Department of Energy
Washington, D.C. 20545
Docket No. 50-537
HQ:S:82:149

MEETING SUMMARY FOR THE SHUTDOWN HEAT REMOVAL MEETING, DECEMBER 16, 1982

BRIEFING ON
CRBRP SHUTDOWN HEAT REMOVAL CONCERNS

Shutdown Heat Removal Meeting
December 16, 1982
Agreements and Commitments

SIMPLIFIED HYDRAULIC PROFILE—PHTS REACTOR INLET INTO GUARD VESSEL

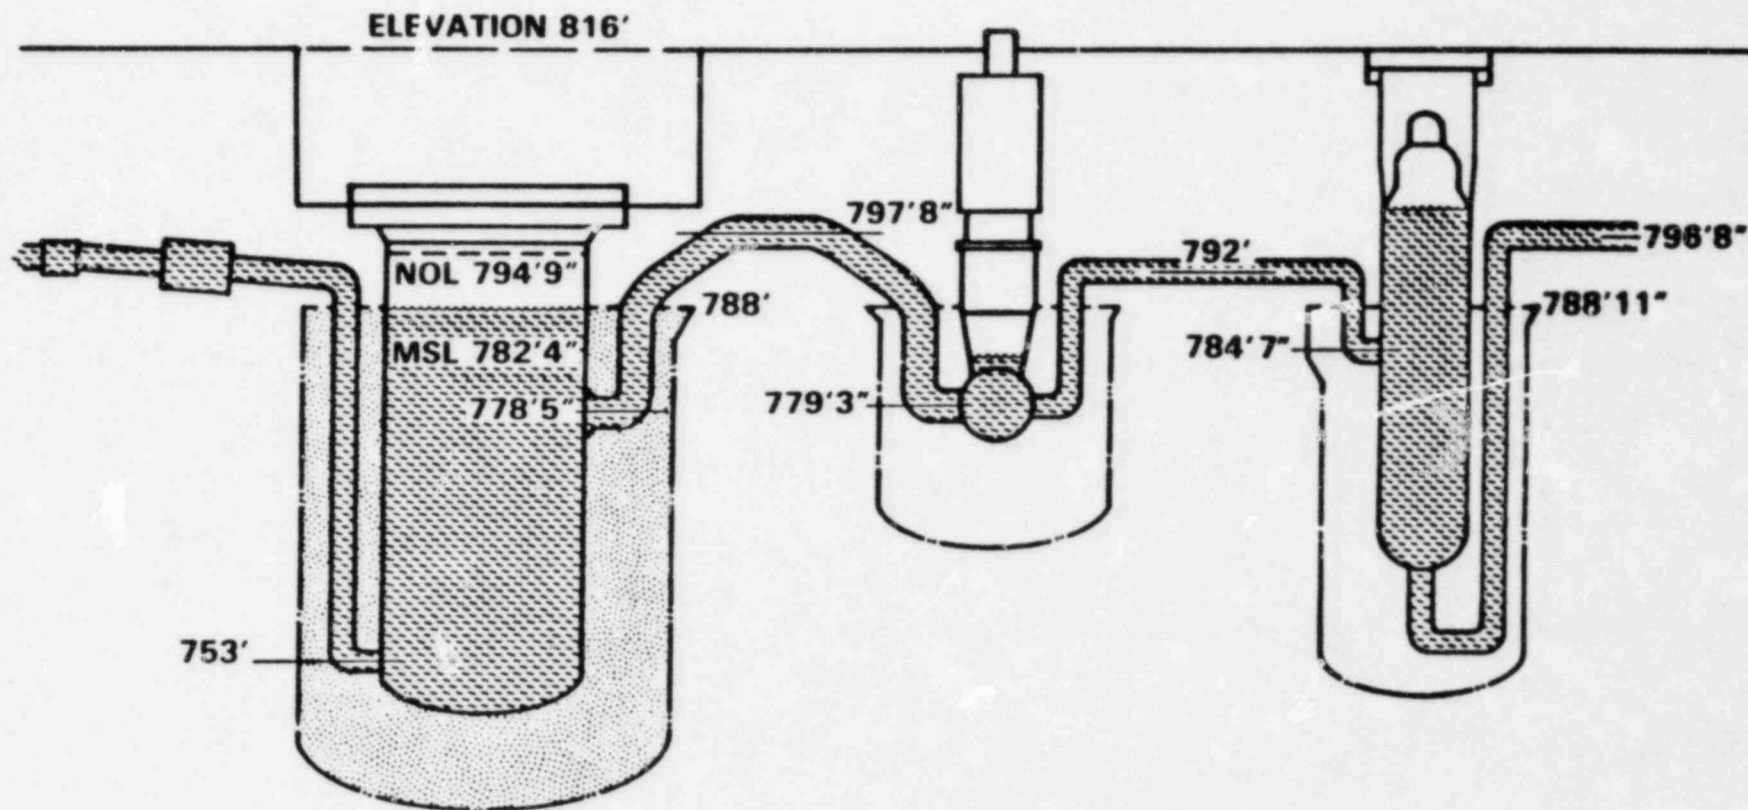
Pipe Break Analysis (see attached)

Action: The DEMO code output and assumptions used for hot leg pipe break analysis will be provided to NRC.
